Pictures on FE-I4B wafers

S. Vähänen 23.5.2013 Advacam

Darkened Al Pads on FE-14 ROIC Wafers

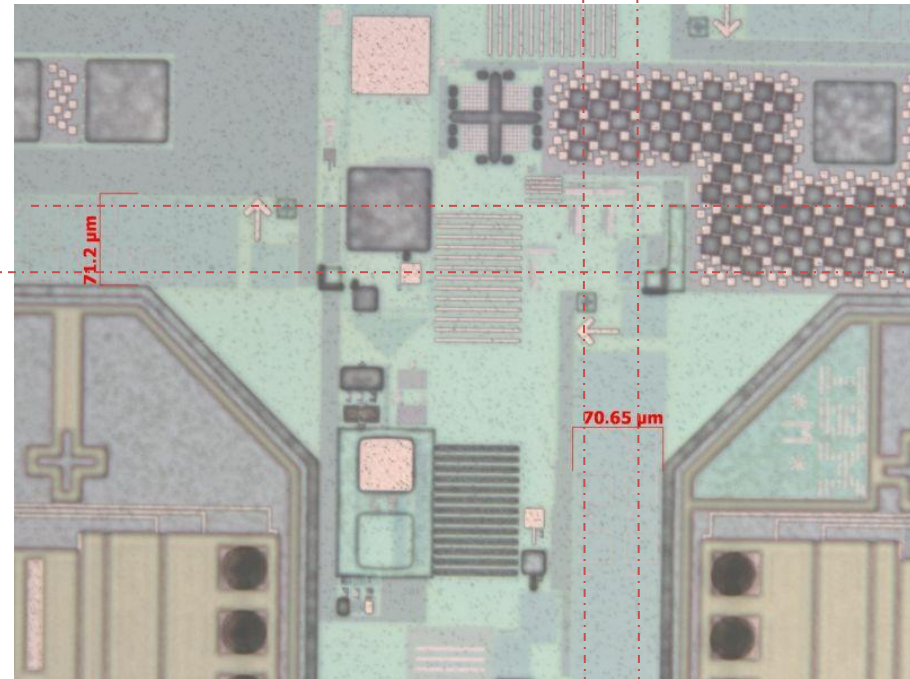
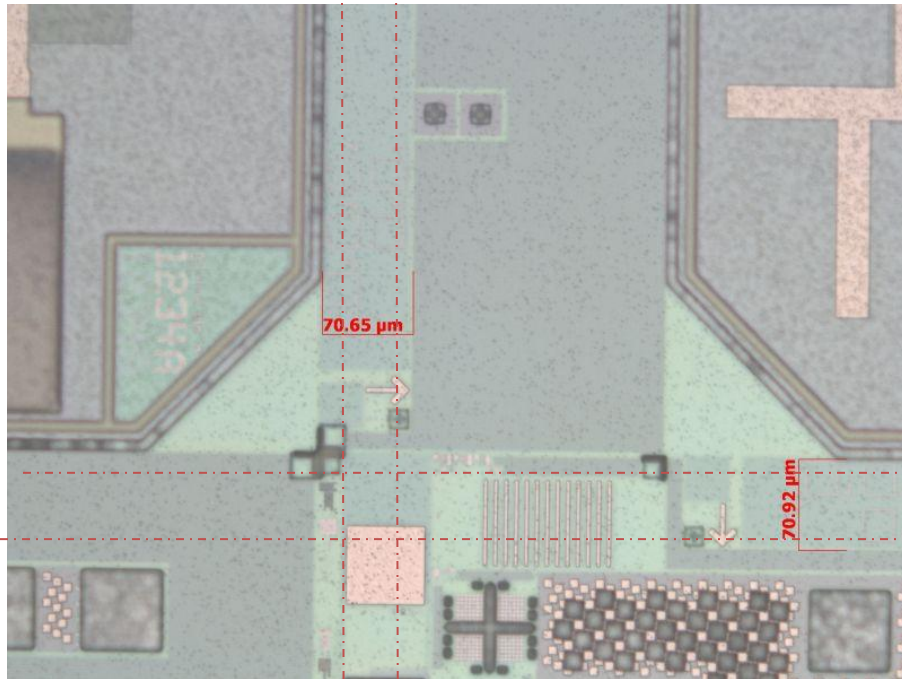
- All the exposed aluminum structures have become dark (rough) during the bumping process
 - Sami's best guess: wet etching chemistry of adhesion layer hasn't been compatible with Al pads
- Effect can be seen all over the wafer
- Wire bondability has been compromised
- Dicing was scheduled for this week
 - What is the next move?

W#WMB8WDH

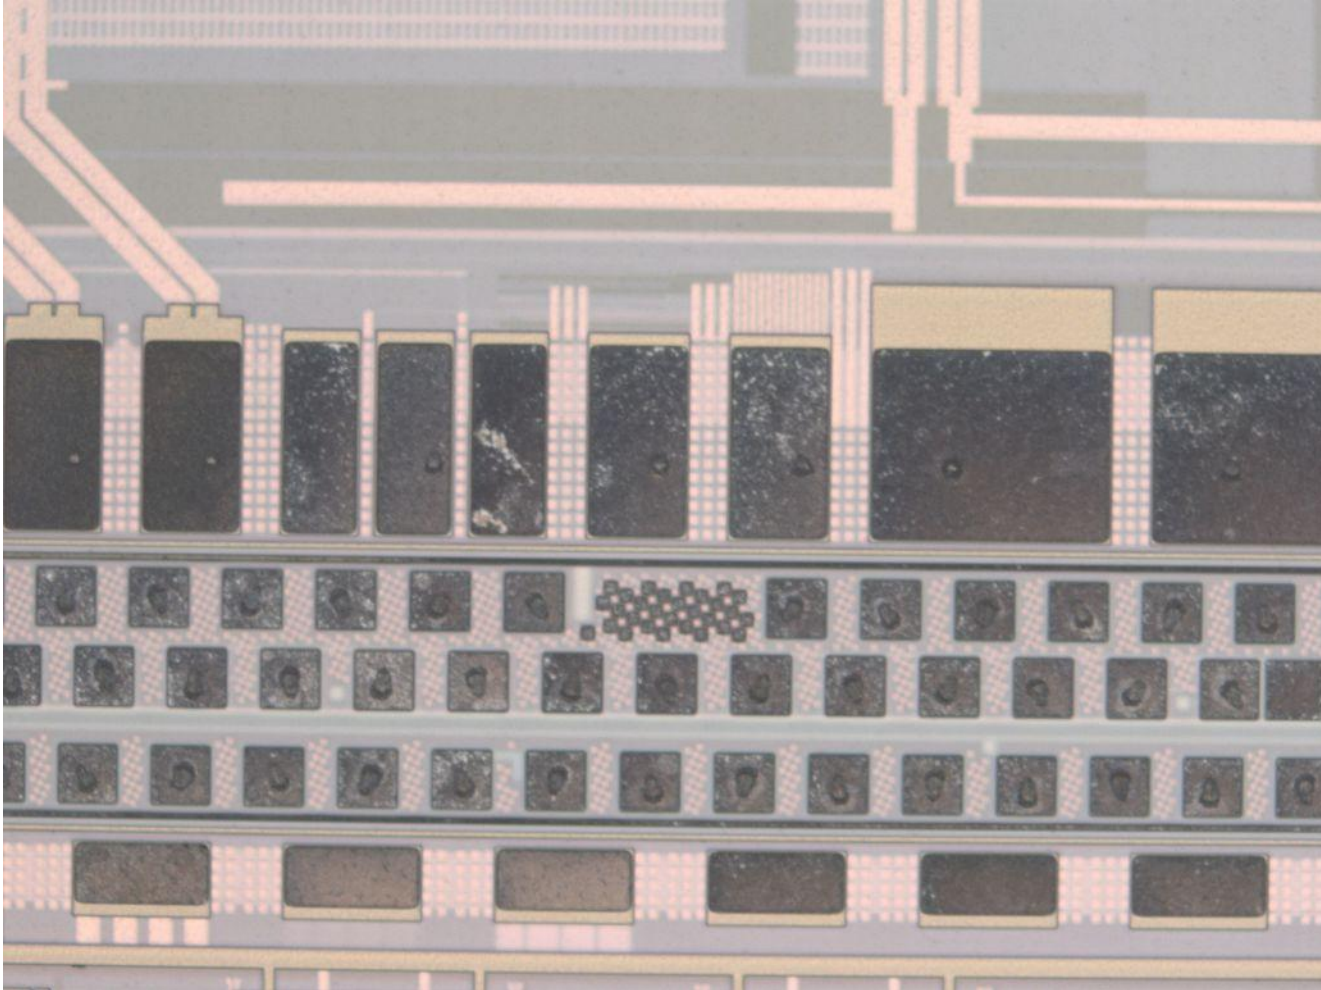
Best location on wafer at very perimeter

No bumps here anymore
